LOUISIANA POWER & LIGHT COMPANY
WATERFORD SES UNIT NC, 3

RESPONSE TO NRC DRAFT - TECHNICAL EVALUATION REPORT (TER) FOR
WATERFORD 3 SES ON CONTROL OF HEAVY LOADS

SUPPLEMENT NO. 1

November 1983

Figure
III

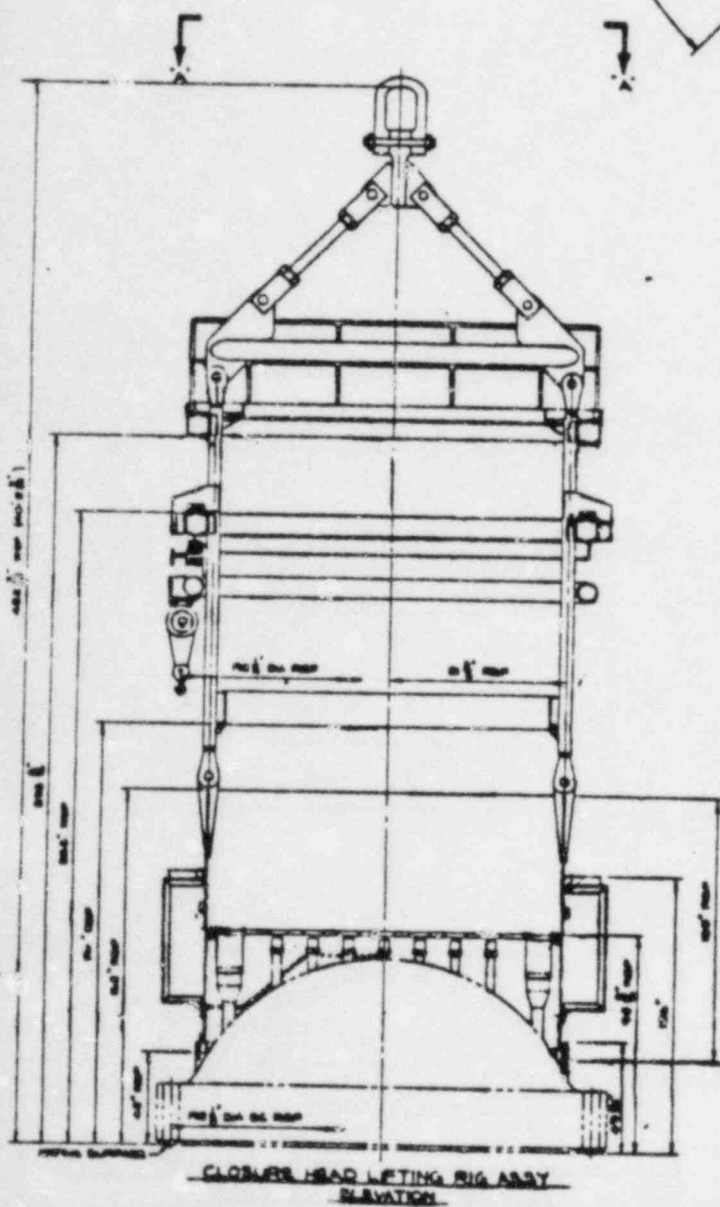
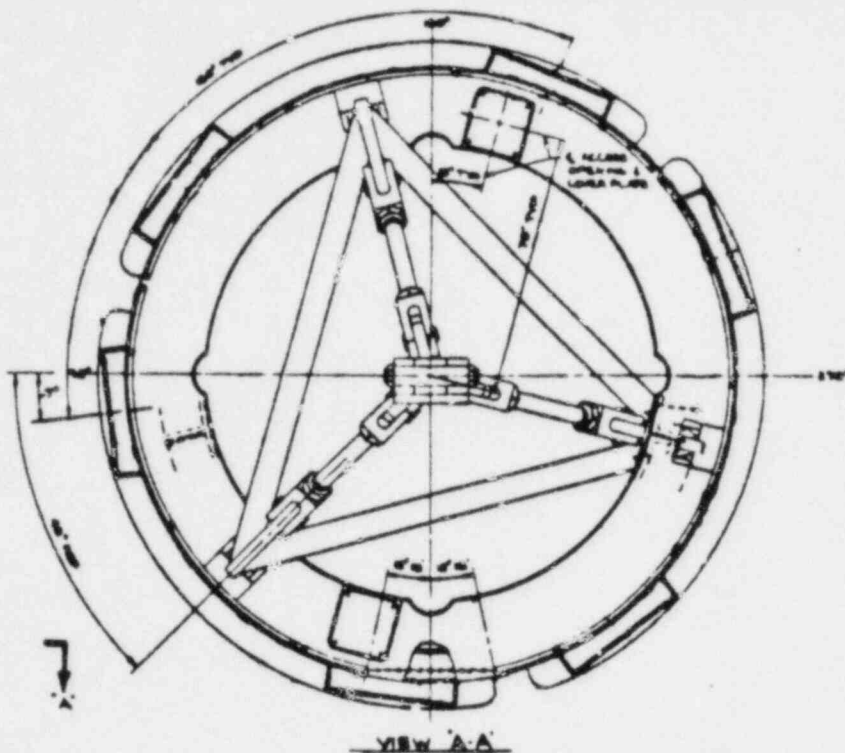
This special lifting device was designed and fabricated before the issuance of ANSI N14.6-1978 and thus does not meet all requirements in the standard. However, the fabrication methods met the intent of the standard. The device was load tested prior to first use and will be inspected before every use.

* The safety margins are lower than required by ANSI H14.6-1978. However, the safety margins are not significantly lower than the required.
